From: <apolonsky@morganlewis.com>
To: <rwebster@kinoy.rutgers.edu>
Date: 3/23/06 10:00AM
Subject: Oyster Creek

NRC Information Request Form

Item No
AMP-210

Subject: Oyster Creek Dry Well Corrosion
Comments regarding "Audit Q&A (Question Numbers AMP -141,
210, 356) dated 4/5/06, Ref. ML060960563

Figure 1

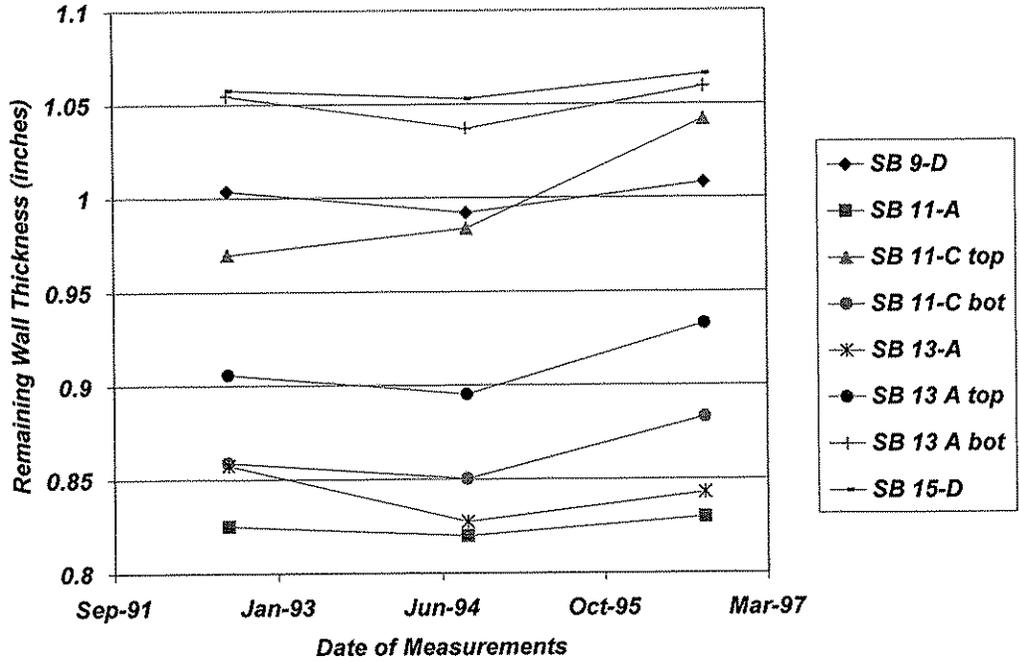
Presumably the identical grid locations, which were surveyed in September of 1992, were again surveyed in September of 1994 and September of 1996. This generated three data points (AMGT) in each of the various bay locations as a function of time. Plots were then generated to show the AMGT as a function of time. These plots are shown in the Figure 1 below for 8 different bay locations, correlating the measurements as a function of time. Exelon drew straight horizontal lines through these points with extrapolation over the next 10 years to demonstrate the absence of continued corrosion.

First, it is noted that with unflinching regularity (even in the cases not shown in Figure 1 below) the AMGT for each grid decreases from 1992 to 1994, but then *increases* in 1996. This is of course physically impossible; metal simply does not spontaneously get thicker. Furthermore, statistically, UT measurements in general are accurate within a standard deviation of 2% of wall thickness (modern methodologies can do better). Assuming for a moment that all 49 measurements within a grid measured the same wall thickness, then the average would have had a standard deviation of $2/7$ % or about 0.3% of wall thickness which corresponds to +/- 2.5 mils or 95% confidence limits of +/- 5 mils. Since however, not all measurements within the grid were of the same wall thickness, the variability of individual measurements within the grid must have been larger than the standard deviation derived from instrument capability. Exelon assures us that "the tolerance is or the order of +/- 10 mils. As it turns out, the variability of the AMGT for the three measurements for a particular grid expressed as a standard deviation in almost all cases exceeds the +/- 10 mils by a large margin. **I interpret this as a systematic error in the UT methodology employed.**
